MEMORANDUM

Subject: University Commons Preliminary Site Access and Circulation Review

RS18-3681

SITE ACCESS & CIRCULATION

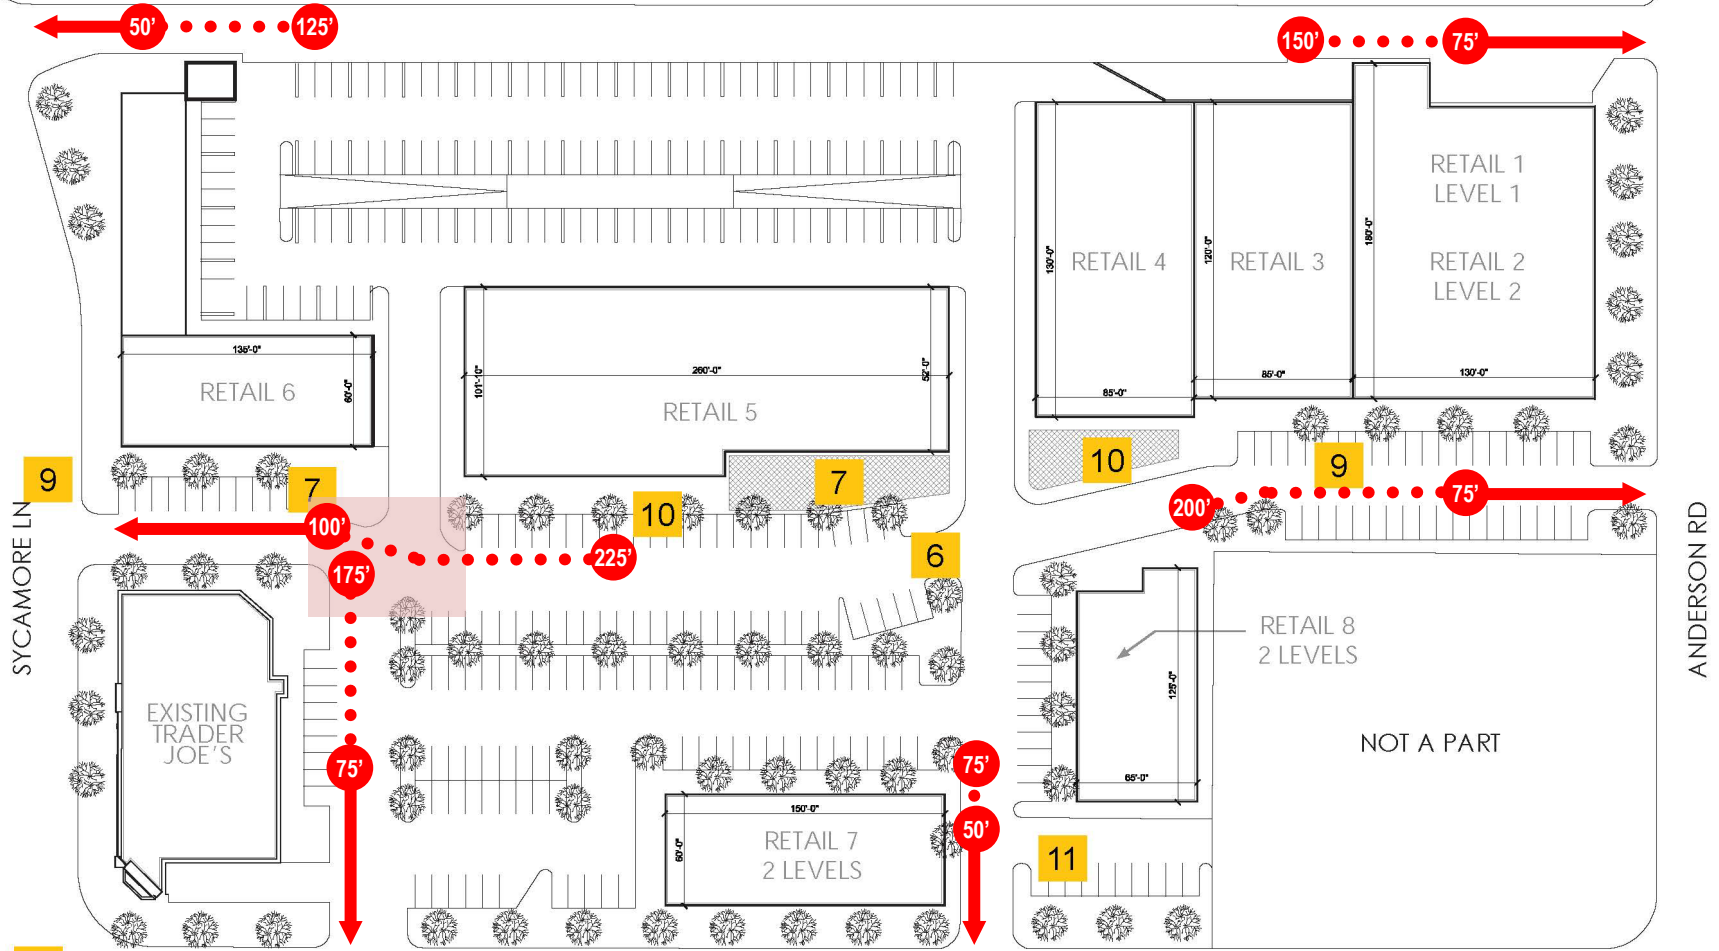
As shown in the attached exhibit, the maximum outbound queues during the PM peak hour would exceed the driveway throat depth at several locations on the project site. This condition could cause queue spillback into the adjacent public roadway at the following locations:

- Southern Sycamore Lane driveway
- Southern Anderson Road driveway
- Western Russell Boulevard driveway

Queue spillback would be particularly problematic at the southern Sycamore Lane driveway and the western Russell Boulevard driveway, since both driveways serve highly desirable parking stalls in close proximity to the Trader Joe's entrance (i.e., motorists would be willing to wait longer to access a convenient parking location).

Potential strategies to minimize the effects of queue spillbacks and on-site circulation include the following:

- Southern Sycamore Lane driveway
 - a. Eliminate parking stalls along the Retail 6 frontage
 - b. Provide exclusive outbound left-turn and right-turn lanes

- Southern Anderson Road driveway
 - a. Eliminate parking stalls along the Retail 1, 2, and 3 frontages
- Western Russell Boulevard driveway
 - a. Align with the drive aisle north into the parking garage, shift further east into the project site (this would also provide additional throat depth for the southern Sycamore Lane driveway), and close off access for the southernmost east-west drive aisle to/from the west (opposite the Trader Joe's loading dock), OR

- b. Consolidate Russell Boulevard driveways into a single driveway at or immediately west of the eastern Russell Boulevard driveway and provide a driveway throat depth of 150' (the greatest distance that is reasonably feasible given the planned on-site structures). A driveway throat depth of 150' would roughly align with the primary internal east-west drive aisle shown on the site plan.
